NOTICE OF ADDENDUM ADDENDUM NO. 1

CONTRACT NO. 8850, PROJECT NO. 11971 WARNER BEACH PARK SHELTER

Pre-Bid Meeting/Site Visit
WARNER BEACH PARK SHELTER
CITY OF MADISON - CONTRACT #8850

K&E 195L 250-9-60

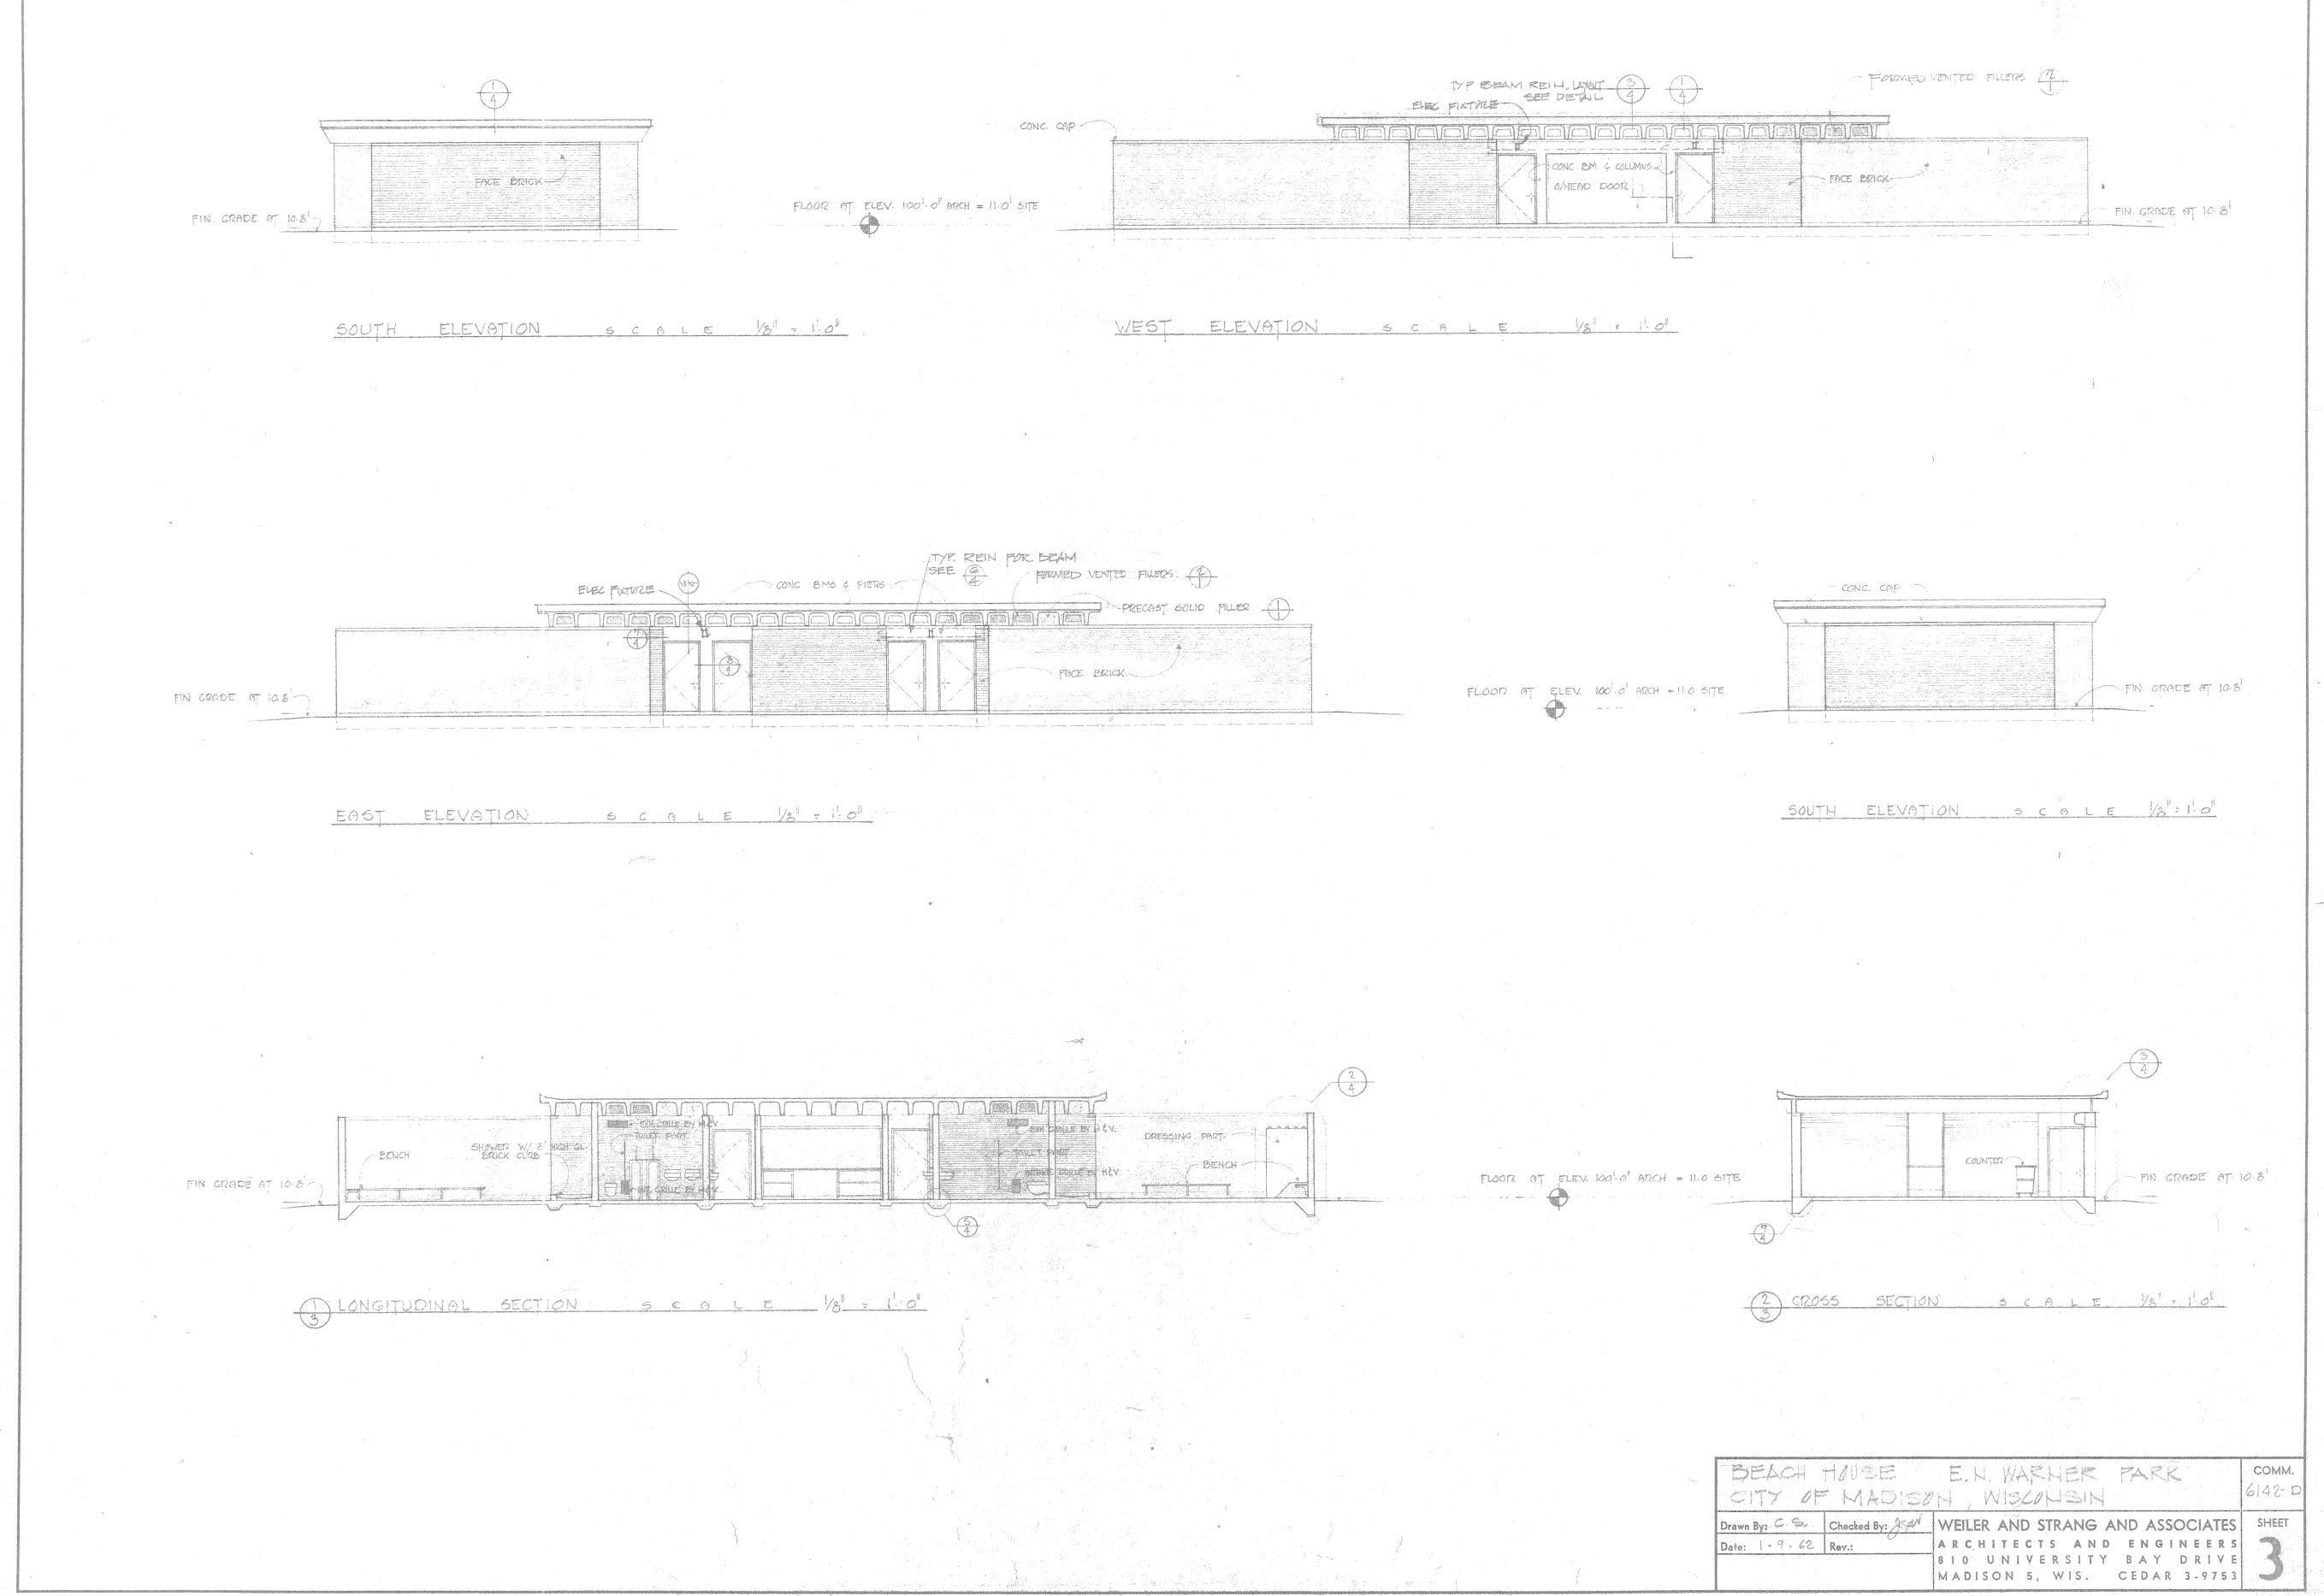
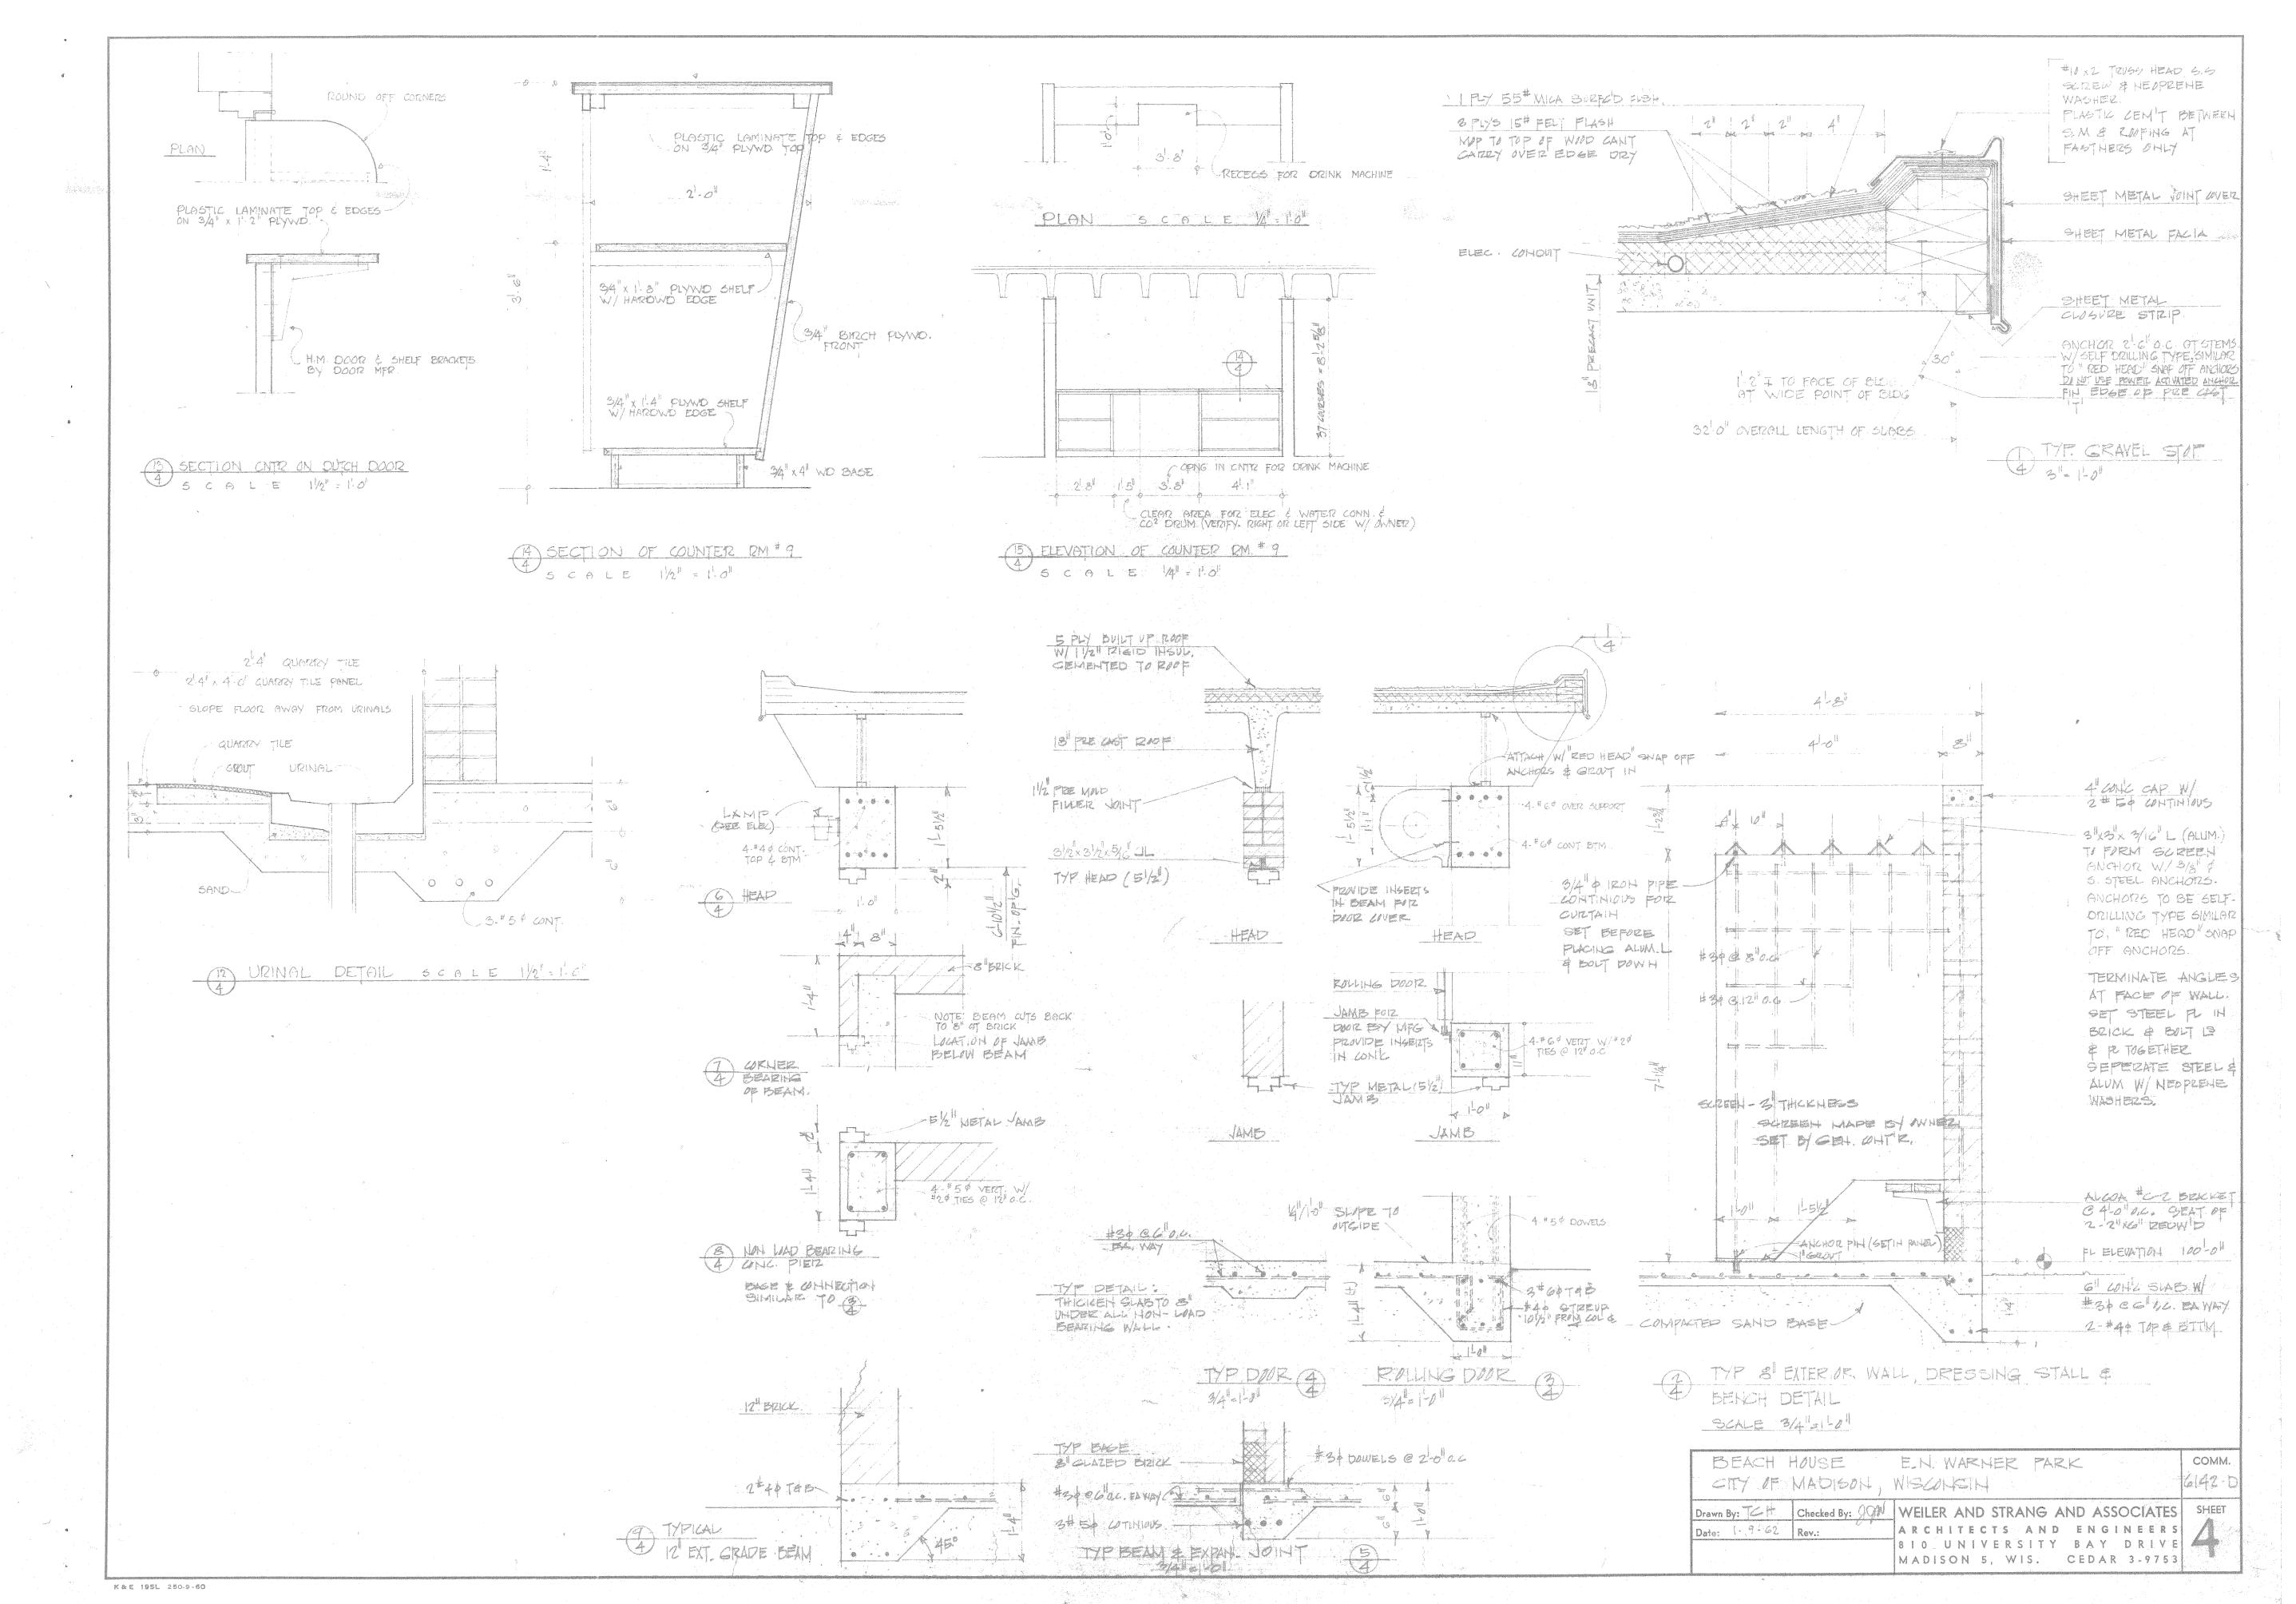
Q1: What is the foundation of the existing building?

A1: Existing plans show grade beams at the building perimeter and thickened slab under non load bearing masonry walls. See Addendum 1, Exhibit K
